PROJECT
RESERVE AT THE BALLPARK, PHASE II, AKA REVEL AT THE BALLPARK
2885 CRESCENT PKWY
SMYRNA, GA 30080

| ISSUES & REVISIONS | DATE |
|--|------------|
| 5. BUILDING PERMIT COMMENTS / COORDINATION | 10/02/2017 |

DATE 05/22/2017
JOB NUMBER 1493101
DRAWN BY EKS/NB
CHECKED BY CW
SHEET TITLE BUILDING 1000A - PROJECT LEVEL 1
SHEET NUMBER A1-11A
COMMENTS BUILDING PERMIT RE-SUBMISSION
30X42 © 2017 The Preston Partnership, LLC

1 BUILDING 1000A - PROJECT LEVEL 1
0 4 8 16
SCALE: 1/8" = 1'-0"

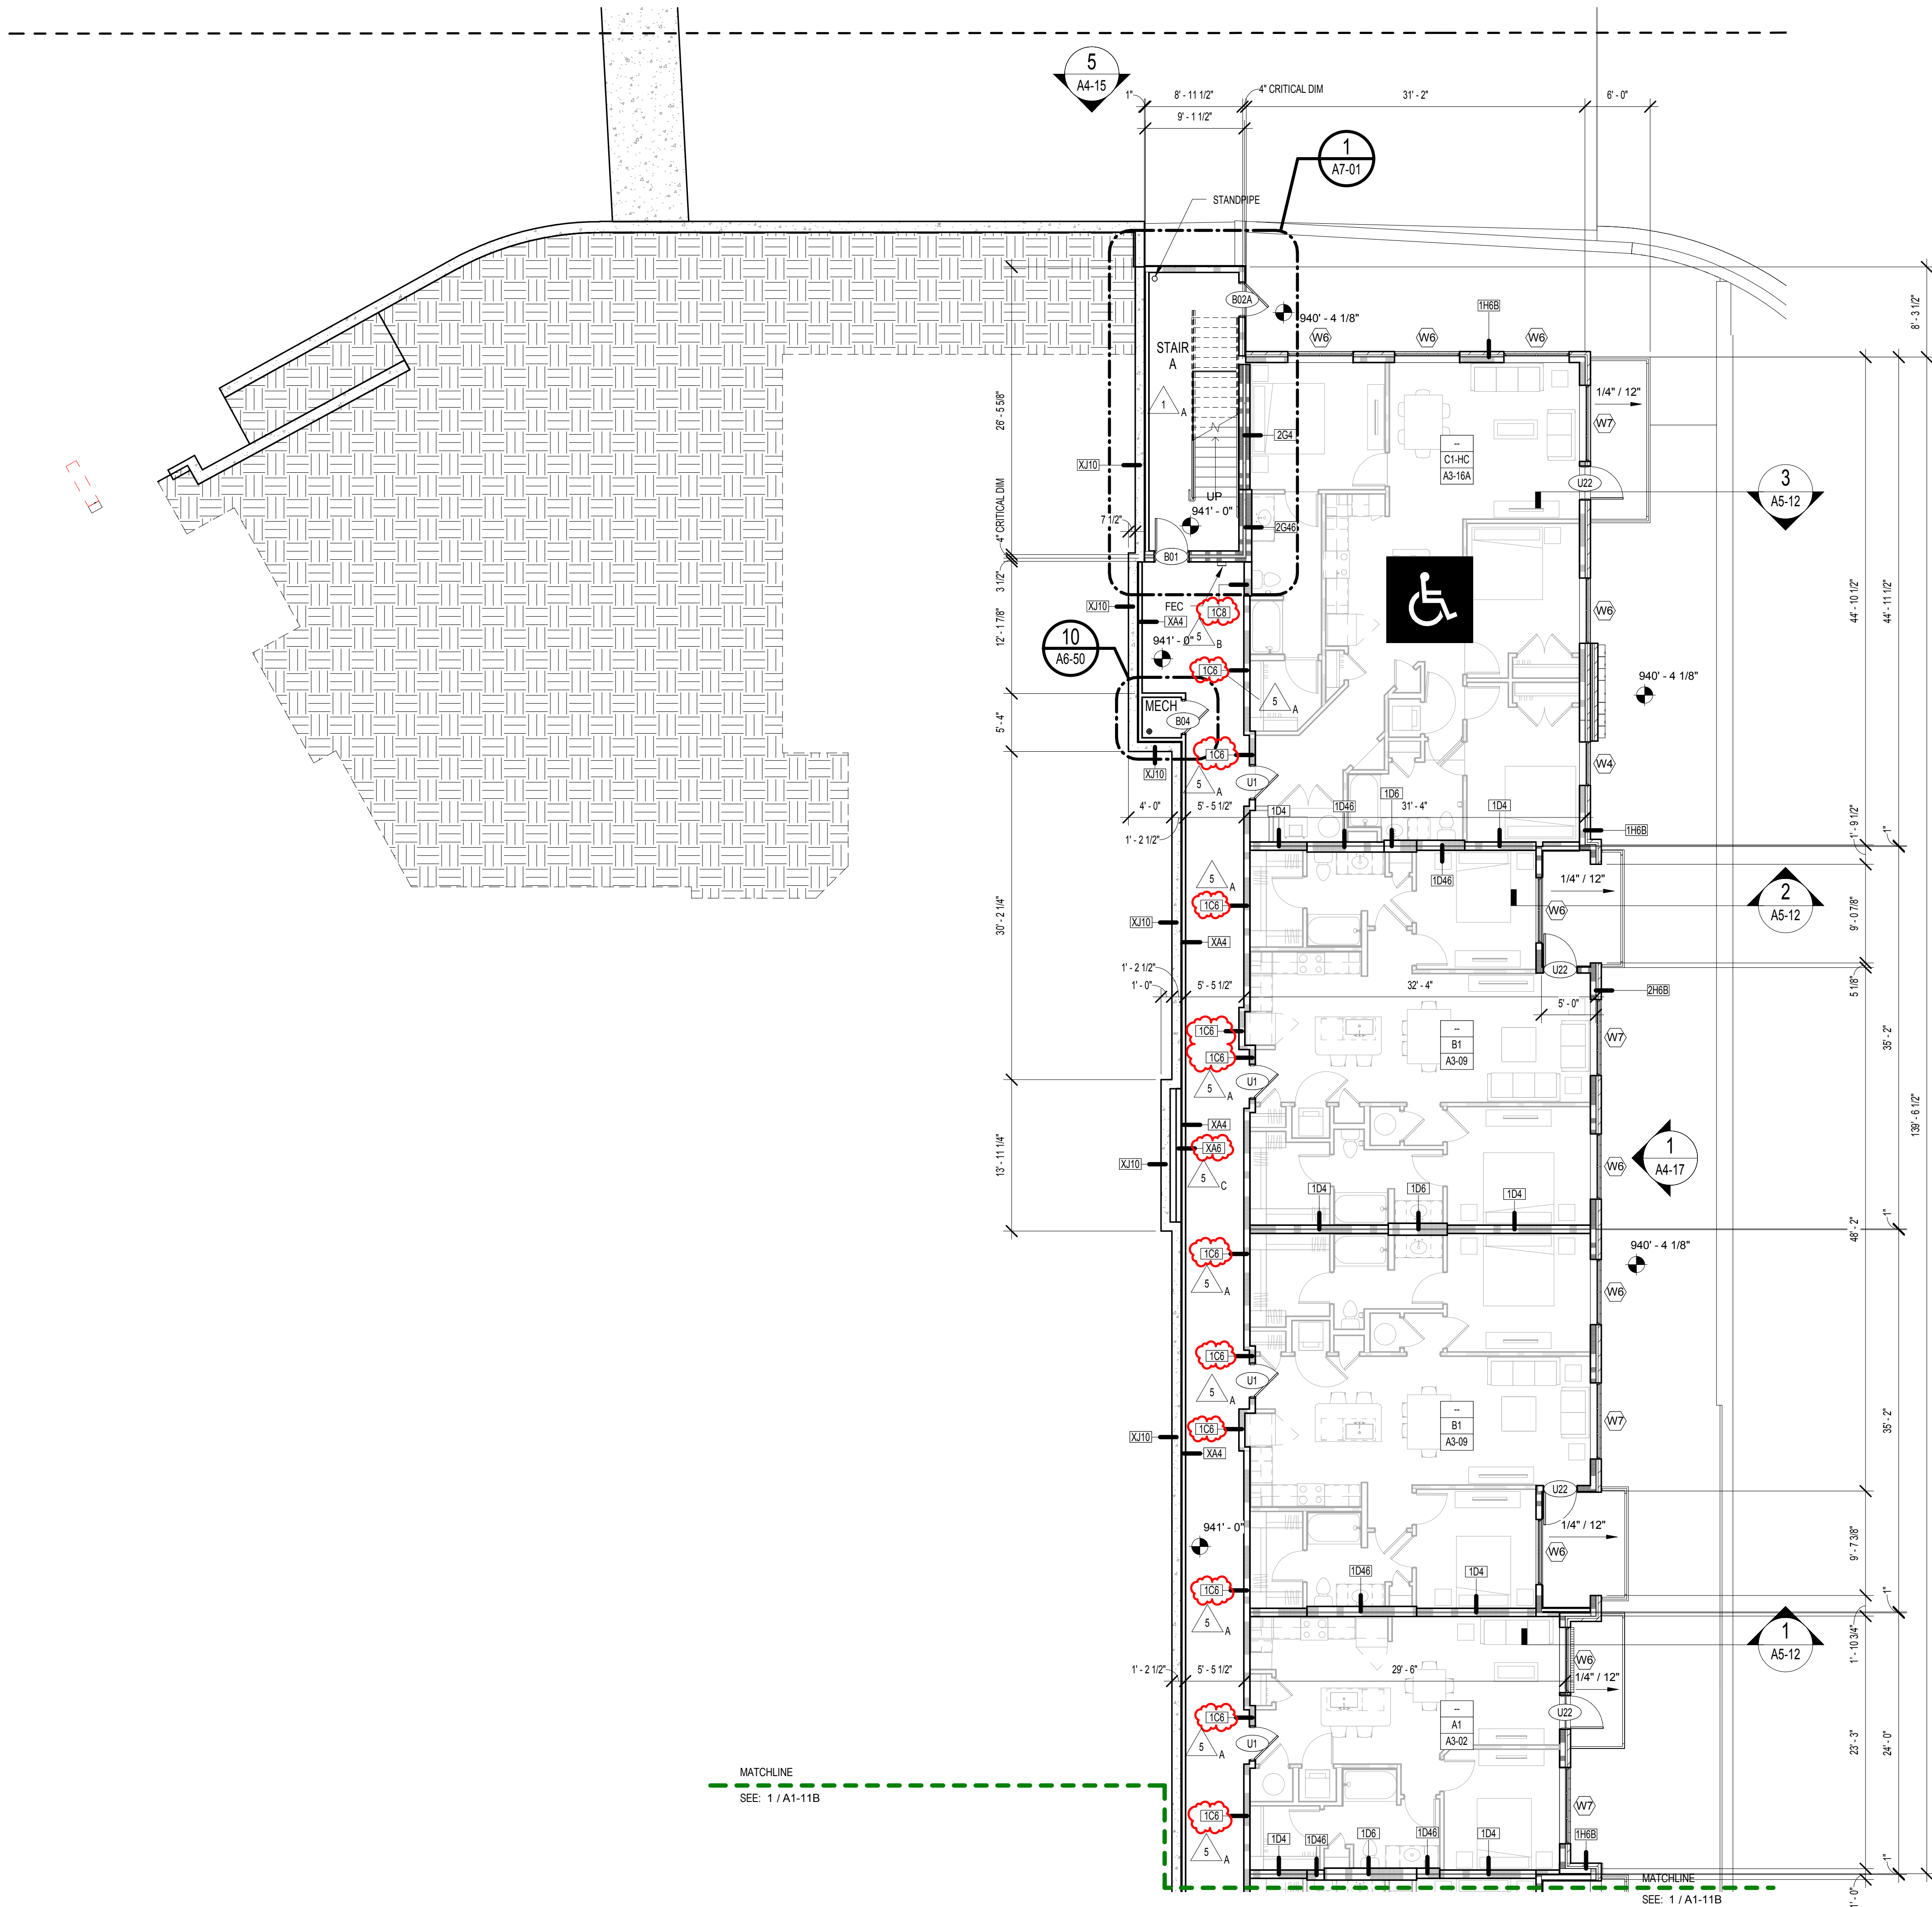
REVISION SUMMARY #1
A. REVISED STAIR LABELS TO ALPHA CHARACTERS
REVISION SUMMARY #5
A. CHANGED WALLS ON LEVEL 1 TO 6" STUDS PER STRUCTURAL
B. CHANGED WALL TO 8" STUD TO ALIGN WITH 6" CORRIDOR WALL
C. ADDED 6" STUD WALL TO ALIGN WITH WALL ON LEVEL 2
